MILITARY SPECIFICATION

MODULES, STANDARD ELECTRONIC

SWITCH, ANALOG, ANALOG, KEY CODE TTY

This amendment forms a part of Military Specification MIL-M-28787/57A(EC), dated 25 October 1978, and is approved for use by the Naval Electronic Systems Command, Department of the Navy, and is available for use by all Departments and Agencies of the Department of Defense.

FIGURE 1. TTY module function diagram, analog switch.

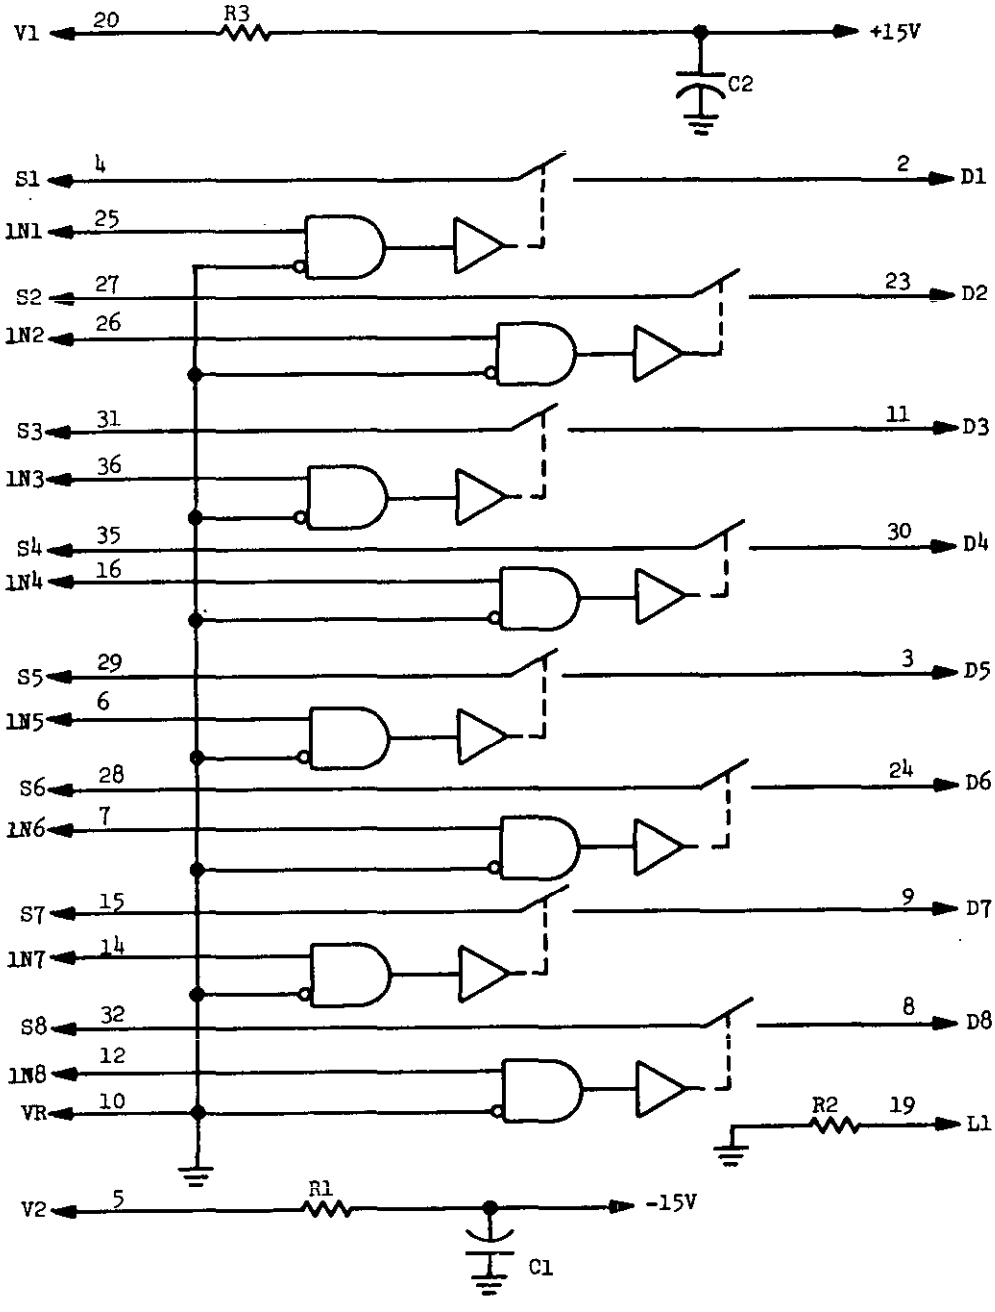
FIGURE 1: Delete and substitute figure 1 as printed on page 3 of this amendment.

NOTES:
1. R1 = R3 = 100Ω.
2. R2 = 4.7 kΩ.
3. C1 = C2 = 2.2 µF.
4. The following pins are not used and each shall be isolated from all other pins: 1, 13, 17, 18, 21, 22, 33, 34, 37, 38, 39, and 40.

FIGURE 5. Analog switch feed thru and distortion test circuit for table IV.

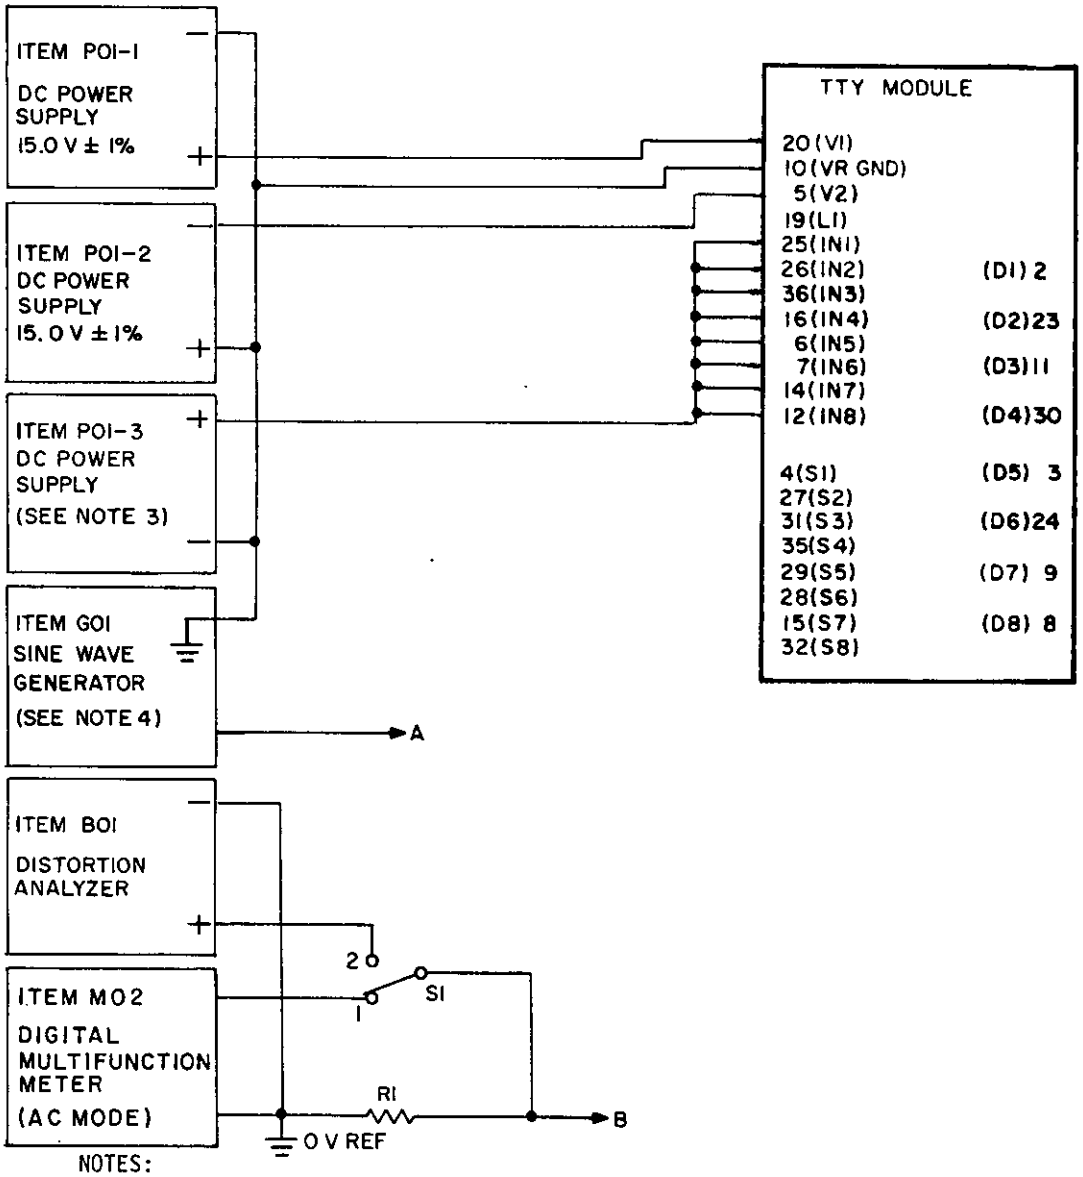
FIGURE 5: Delete and substitute figure 5 as printed on page 4 of this amendment.

NOTES:
1. R1 = 4.7 kΩ ±1%, 1/10 W.
2. S1 = SPDT switch.
3. Set item POI-3 as follows:

a. Test conditions C1-C16 at 0.80 ±0.01 V.
   b. Test conditions D1-D16 at 2.41 ±0.01 V.
   c. Test conditions E1-E8 at 2.41 ±0.01 V.

4. Set item GOI as follows:

a. Test conditions C1-C16 at 5.0 Vrms ±1%, 10 kHz ±1%.
   b. Test conditions D1-D16 at 5.0 Vrms ±1%, 10 kHz ±1%.
   c. Test conditions E1-E8 at 4.0 Vrms ±2%, 10 kHz ±1%.

5. Set switch S1 as follows:

a. Test conditions C1-C16 at position 1.
   b. Test conditions D1-D16 at position 1.
   c. Test conditions E1-E8 at position 2.

FIGURE 6. Resistance test circuit for table V.

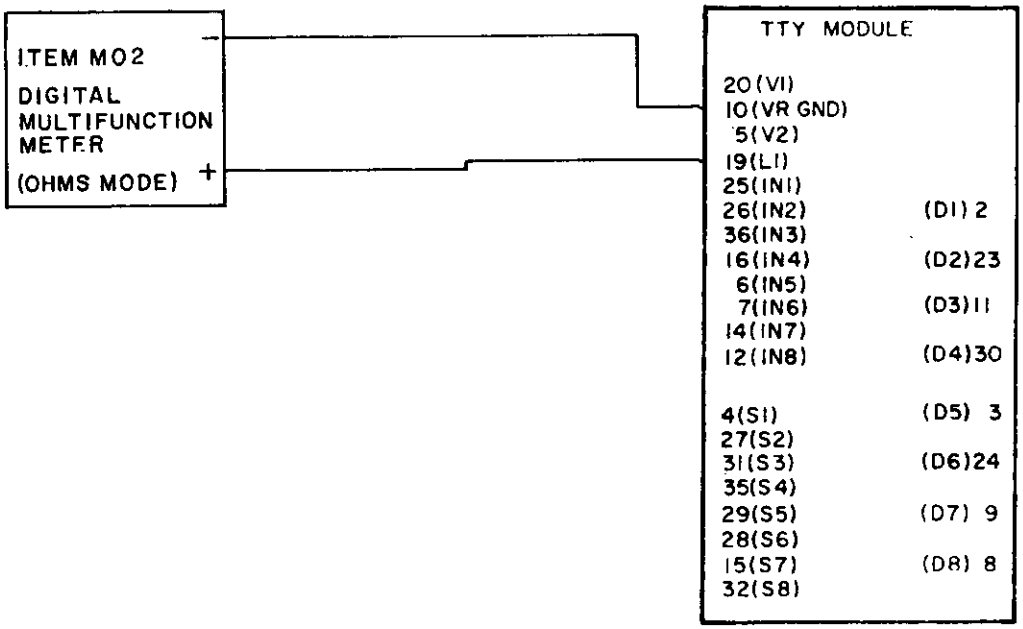
FIGURE 6: Delete and substitute figure 6 as printed on page 5 of this amendment.

FIGURE 9. Input current test circuit for table VII.

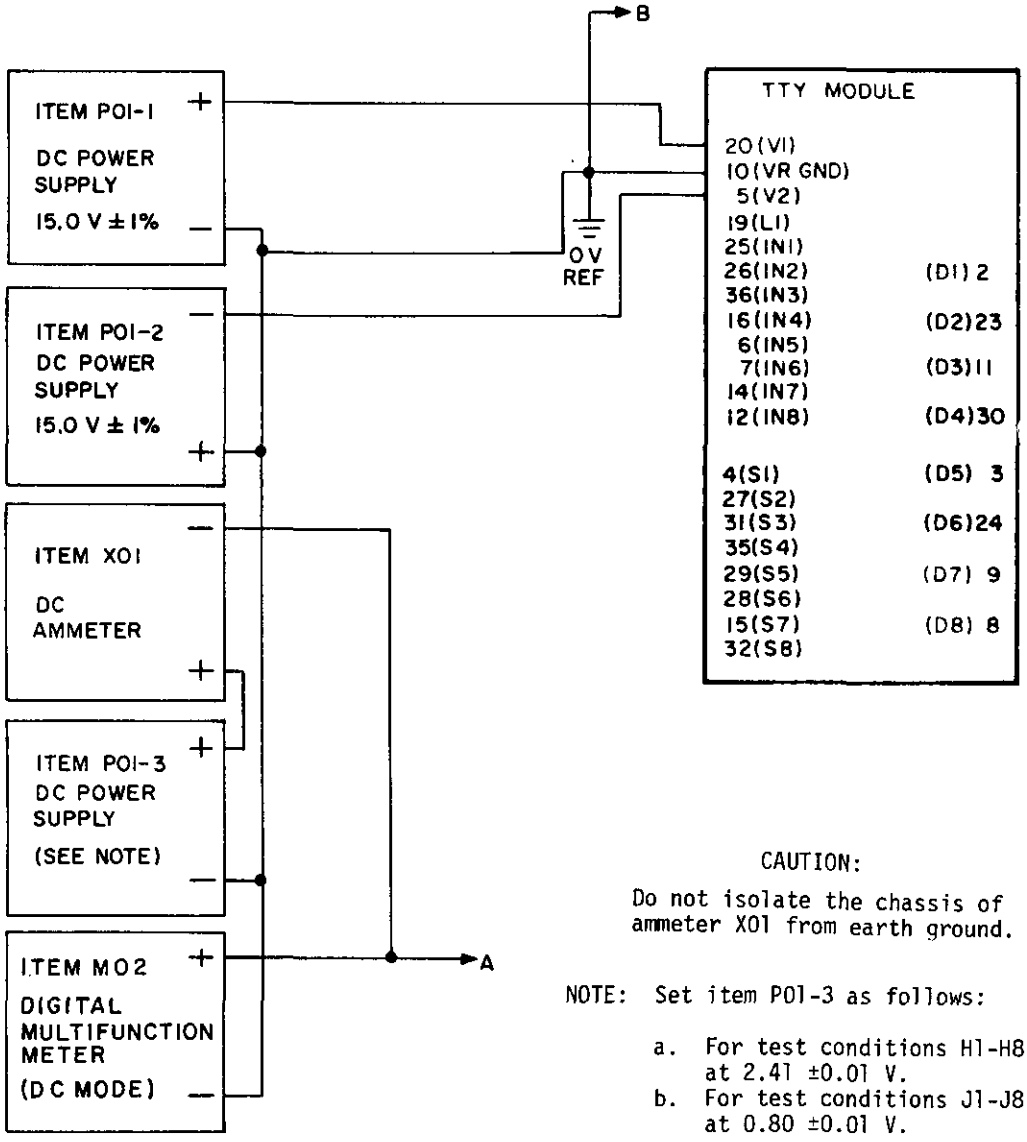
FIGURE 9: Delete and substitute figure 9 as printed on page 6 of this amendment.

FIGURE 10. Analog switch "on" resistance test circuit for table VIII.

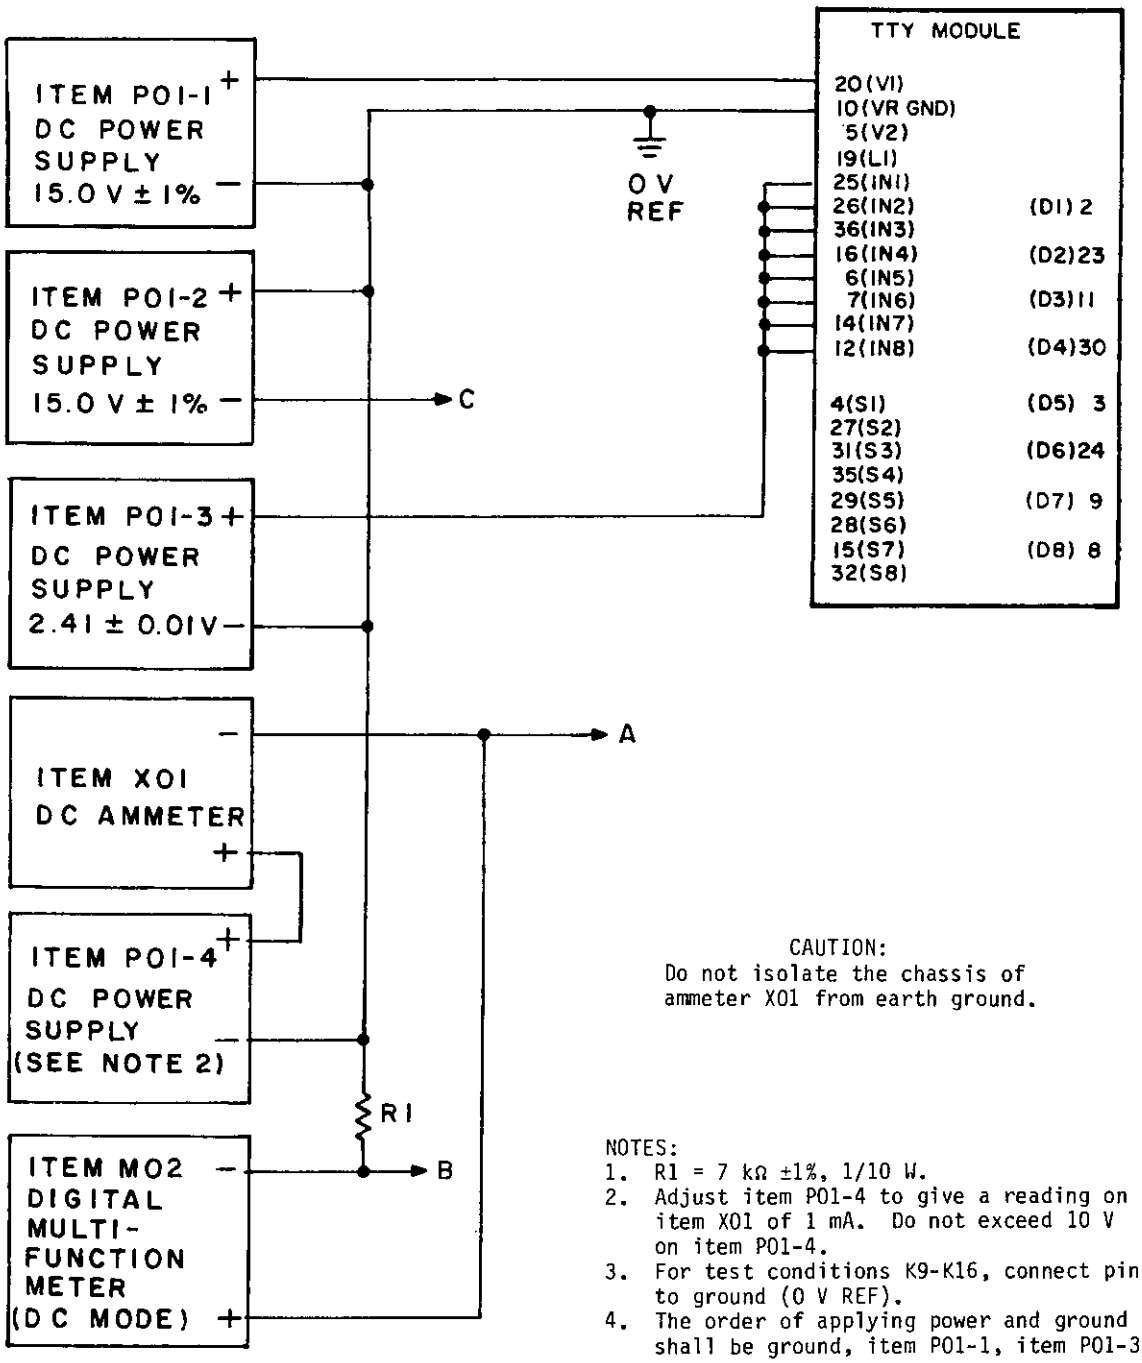
* FIGURE 10: Delete and substitute figure 10 as printed on page 7 of this amendment.

CAUTION:
Do not isolate the chassis of ammeter X01 from earth ground.

NOTES:
1. R1 = 7 kΩ ±1%, 1/10 W.
2. Adjust item P01-4 to give a reading on item X01 of 1 mA. Do not exceed 10 V on item P01-4.
3. For test conditions K9-K16, connect pin 5 to ground (0 V REF).
4. The order of applying power and ground shall be ground, item P01-1, item P01-3.
